JRPP No:	2013SYE041
DA No:	DA 126/13
LGA:	North Sydney
PROPOSED DEVELOPMENT:	74-80 Alfred Street, Milsons Point Adaptive re-use of existing building to accommodate a 16 storey mixed use development comprising retail and commercial, 129 units and basement parking
APPLICANT:	Bridgehill Milsons Point Pty Ltd C/- Urbis
SUBMISSIONS:	Fourteen (14)
RECOMMENDATION	Approval, subject to conditions
REPORT BY:	George Youhanna, Executive Planner North Sydney Council

Assessment Report and Recommendation

South elevation privacy treatment:

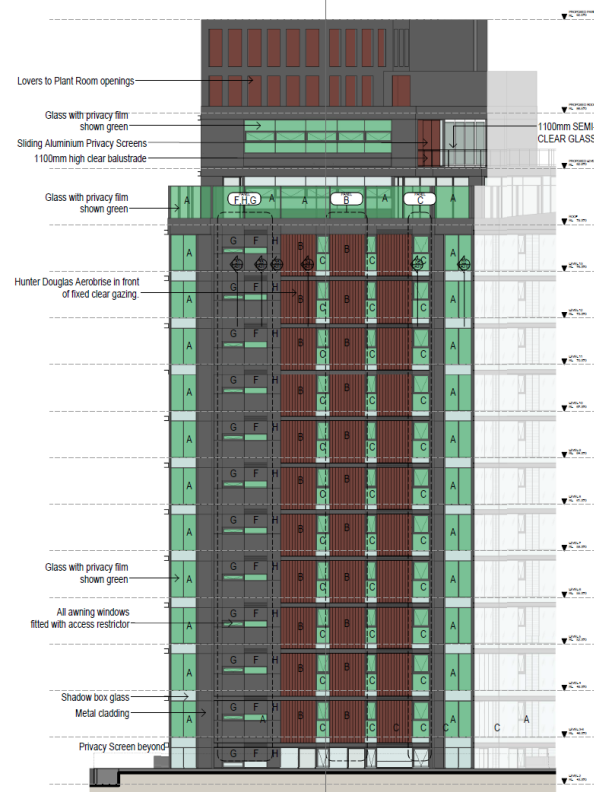
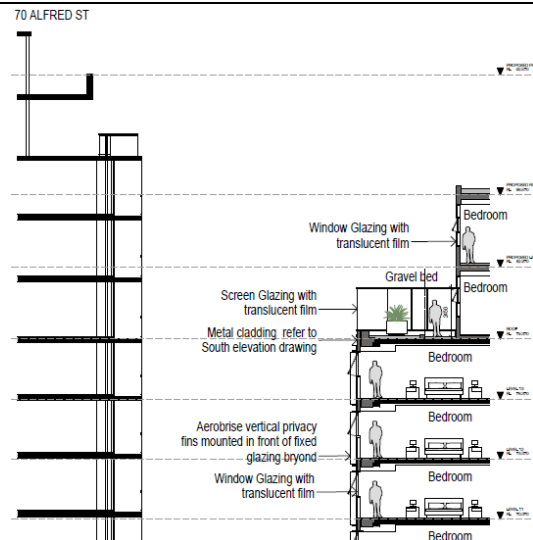
neighbours. The separation distance between the towers of the development and the adjoining building at No.70 Alfred Street ranges from approximately 9.2m at the eastern end up to 13m at the western end. Additional details of the privacy treatment of the southern elevation of the building have been provided by the applicant and the privacy measures include the use of fixed and awning windows and screens, with translucent privacy film, and fixed aluminium vertical louvres (*Hunter Douglas Aerobrise*) set at 45° which direct views in a south-westerly direction.

The use of translucent glazing rather than the proposed use of “translucent privacy film” applied to clear glazing is considered preferable in terms of long term durability, maintenance and privacy, and a suitable condition will be applied in this regard.

Section showing existing concrete hoods(dashed outline), proposed vertical louvres and glass line:

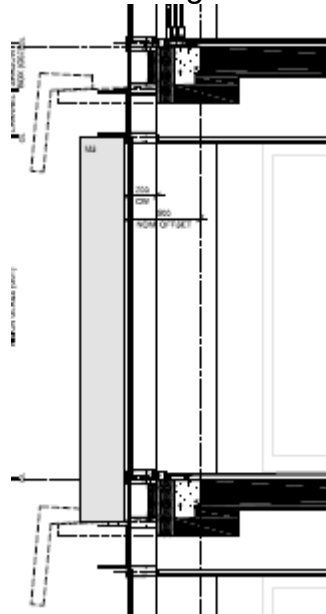
In relation to the existing separation distance between towers, the proposal *technically* increases separation in relation to the removal of the existing concrete shade hoods which presently extend approximately 800mm from the southern facade. However, the glazing line is to be extended towards the south by approximately 500mm, as shown below, marginally reducing the separation distance between habitable rooms.

<p>In the context of adapting an existing commercial building for residential use and with regard to the related design and construction constraints, the proposed placement of the external glass line and the consequential minor reduction in separation distance is considered acceptable, particularly given the proposed privacy measures which will significantly improve privacy at all times of the day.</p> <p>The proposed balconies located on the south-eastern and south-western corners of the building will have translucent glass privacy screens to the southern ends.</p>
Wind Speed	Yes	A wind impact assessment prepared by Windtech was provided with the application. The report concludes that the wind impact will be acceptable and includes recommendations in relation to level 14. Conditions will be applied in relation to the recommendations.
Awnings	Yes	The proposal includes awnings over the Alfred Street footpath, extending around the northern end of the site into Glen Street.

Shadows at 1pm, 2pm and 3pm midwinter:

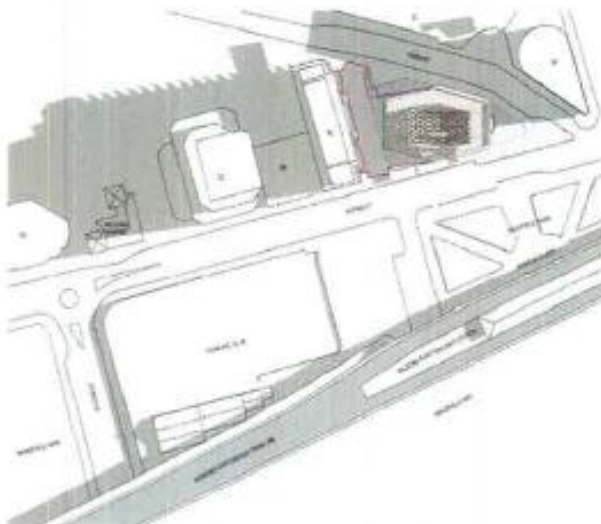
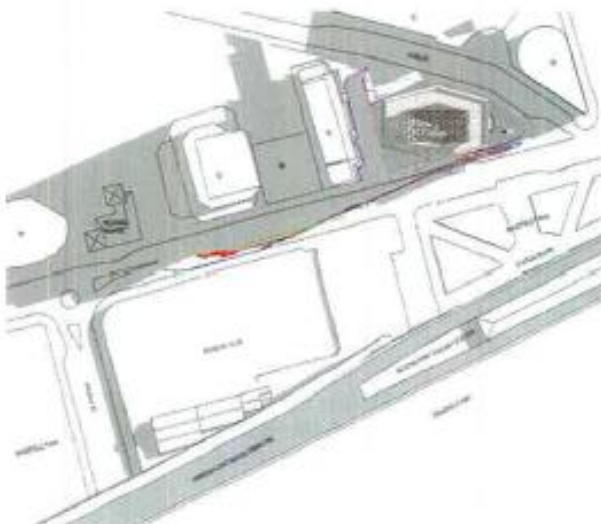
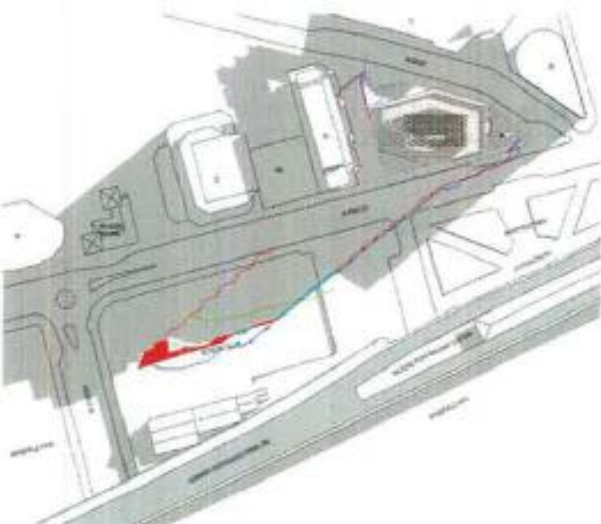
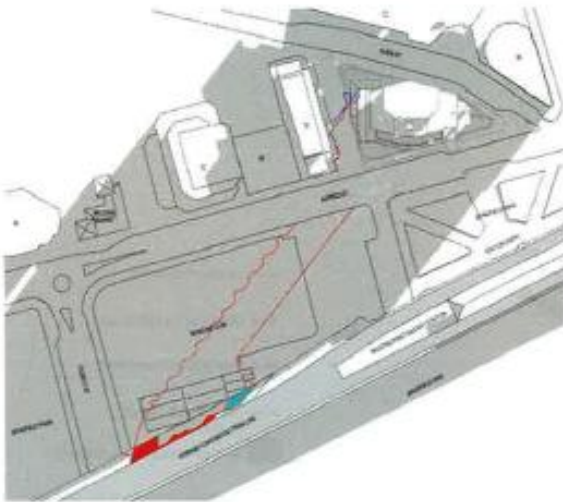
Solar access	Yes	Following concerns expressed by the DEP and Council, the proposal was amended to substantially reduce overshadowing of Bradfield Park at mid winter. The submitted shadow diagrams and associated analysis demonstrates that the amended proposal will now have a minor and acceptable impact on Bradfield Park.
Views	Yes	The proposed rooftop communal room will provide views for residents and the proposed development will not adversely affect views from public areas.
